SUBDIVISION COMMITTEE  
METROPOLITAN AREA PLANNING COMMISSION

STAFF REPORT  
(Final Plat)

CASE NUMBER: S/D 90-70 - PEARSON FARMS 2ND ADDITION

Re: S/D 90-70 (Final Plat) Pearson Farms 2nd Addition

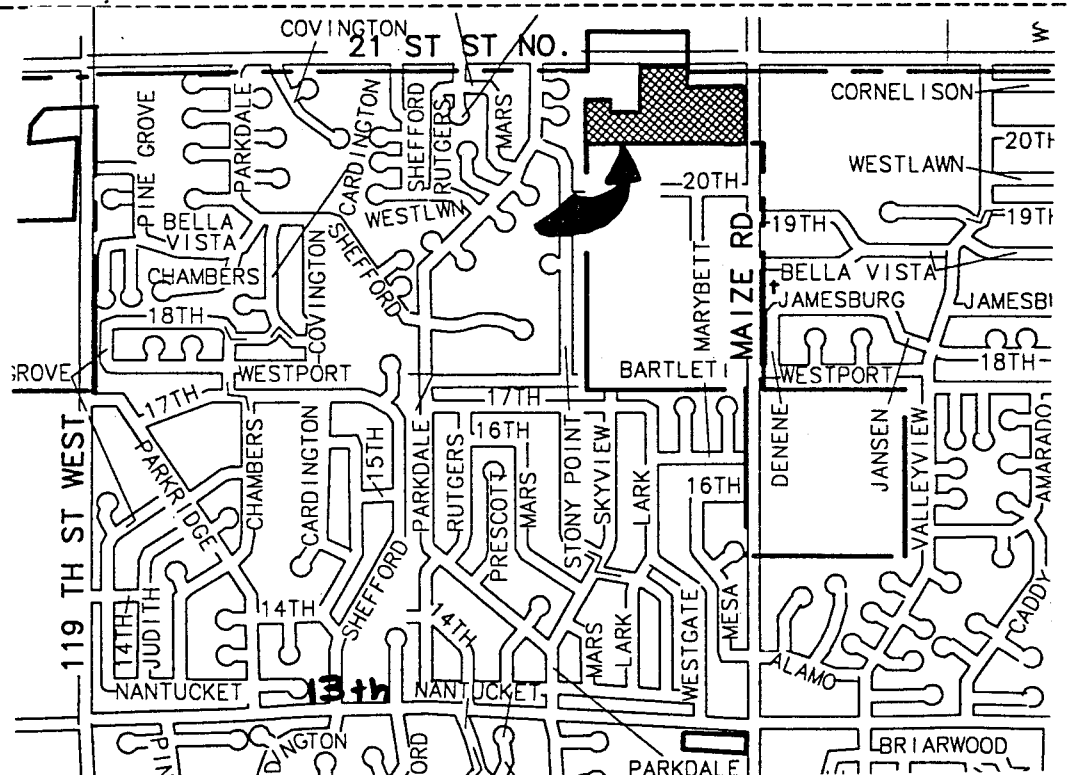
*The original lots 1 & 2  
also drain a cross  
Blat.*
